Addendum No. 1

CITY OF ABERDEEN ABERDEEN, MARYLAND DEPARTMENT OF PUBLIC WORKS

AWWTP Digester Gas Flare Replacement

Engineering Project No. 12563982

REV.	DESCRIPTION	DATE	NAME	DATE	DRAWING NO.
		DEC. 1977			33
		PROJECT NO.			SHEET NO.
		C-240346-01			A-14

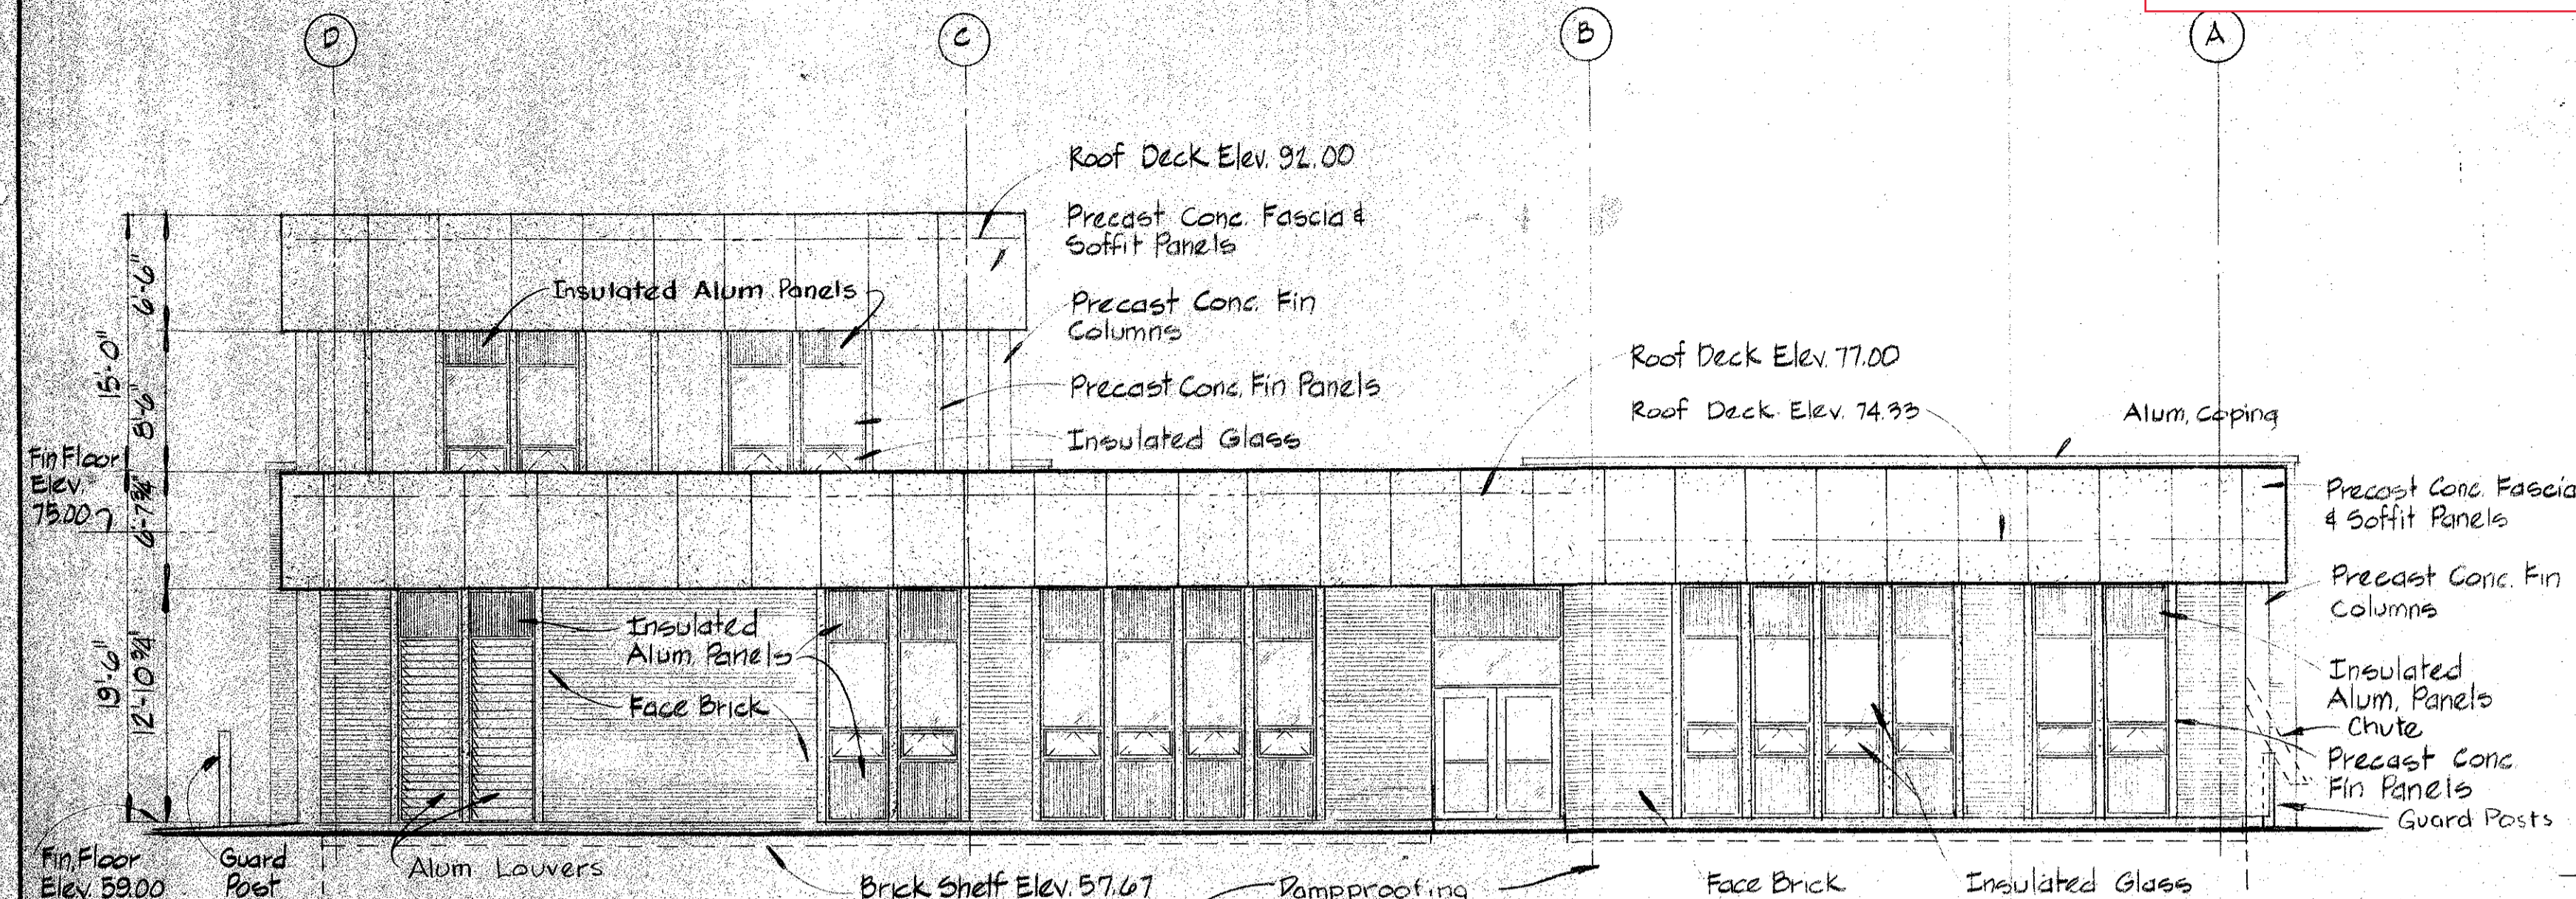
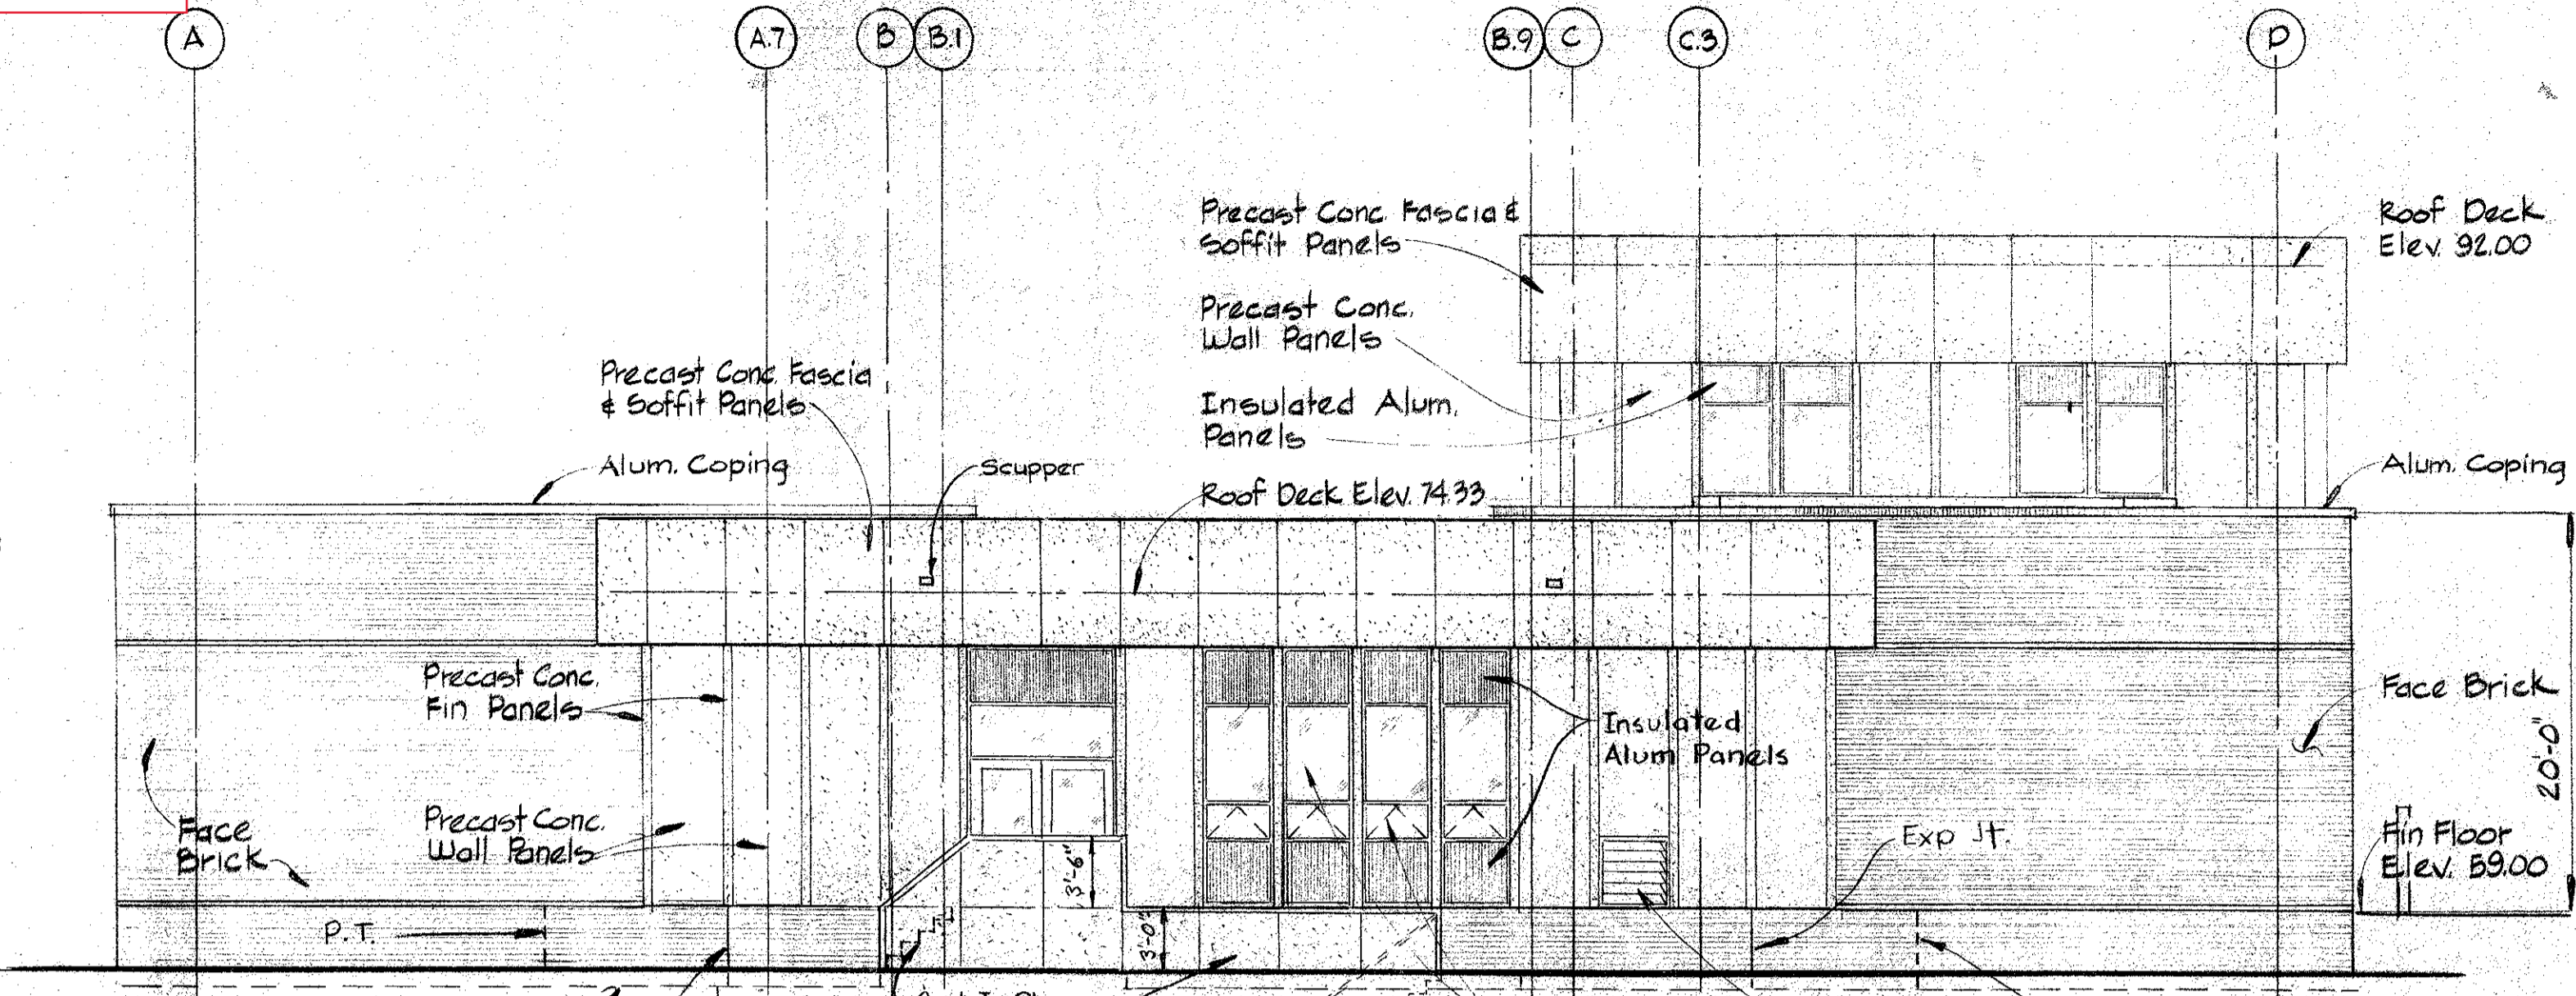
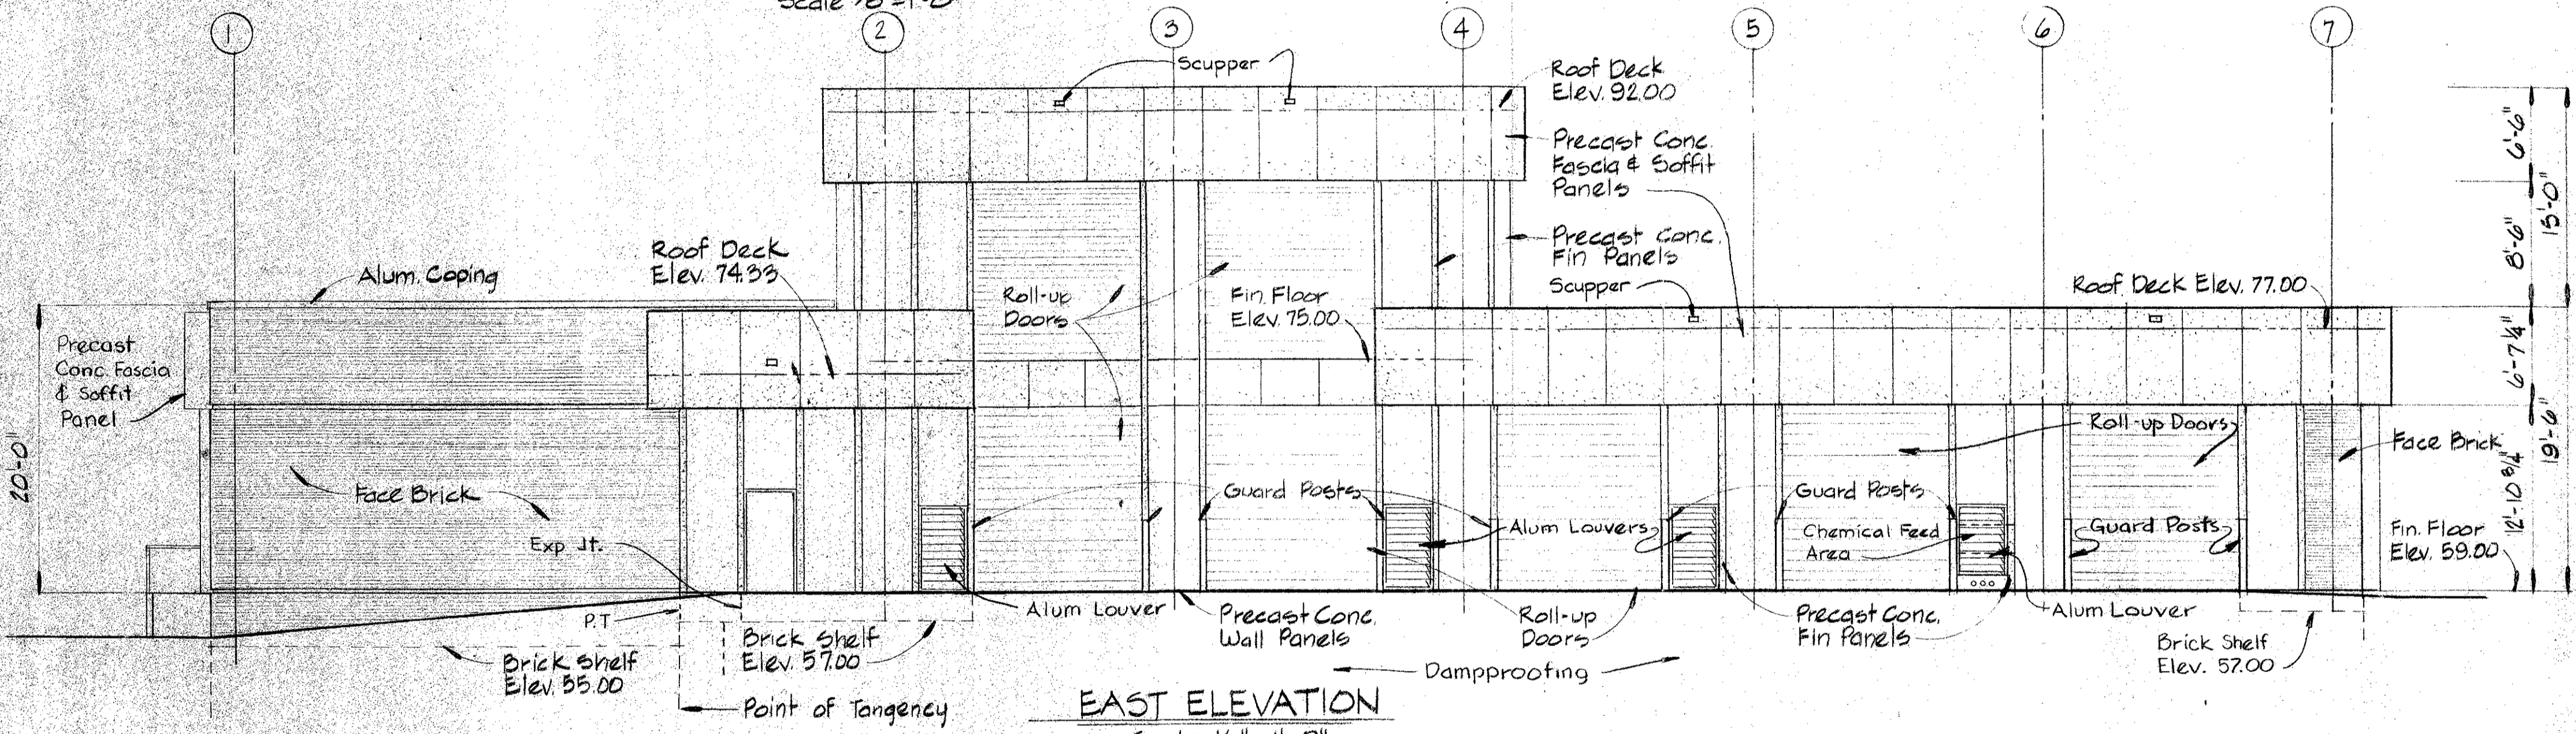
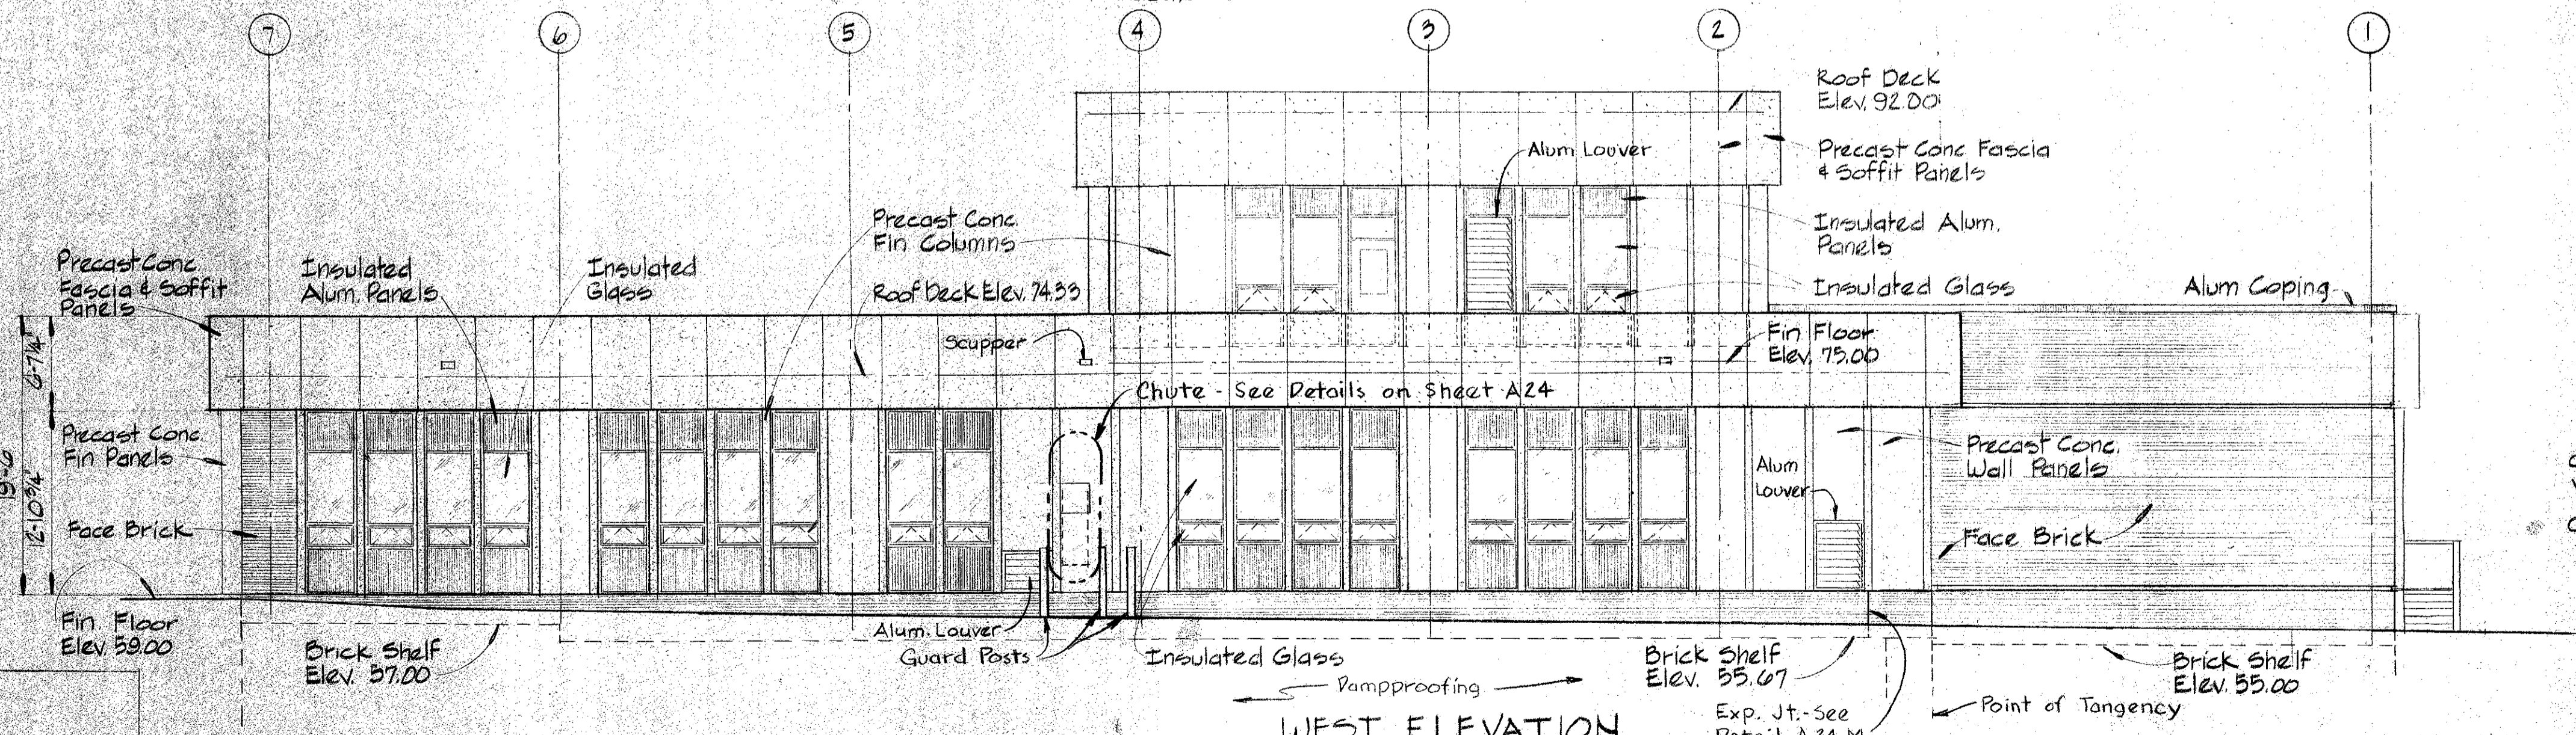
8. *Can any as-built information be provided on the existing aluminum panels that need to be fabricated to match existing on the south side of the building exterior shown on sheet 8.*

- a. The attached record drawings for bidders reference only, from the “Town of Aberdeen Advanced Wastewater Treatment Plant” Drawing No. 33 and 35 show the profile and sectional views of the Administrative Building. The panels are identified as “Insulated Aluminum Panels”
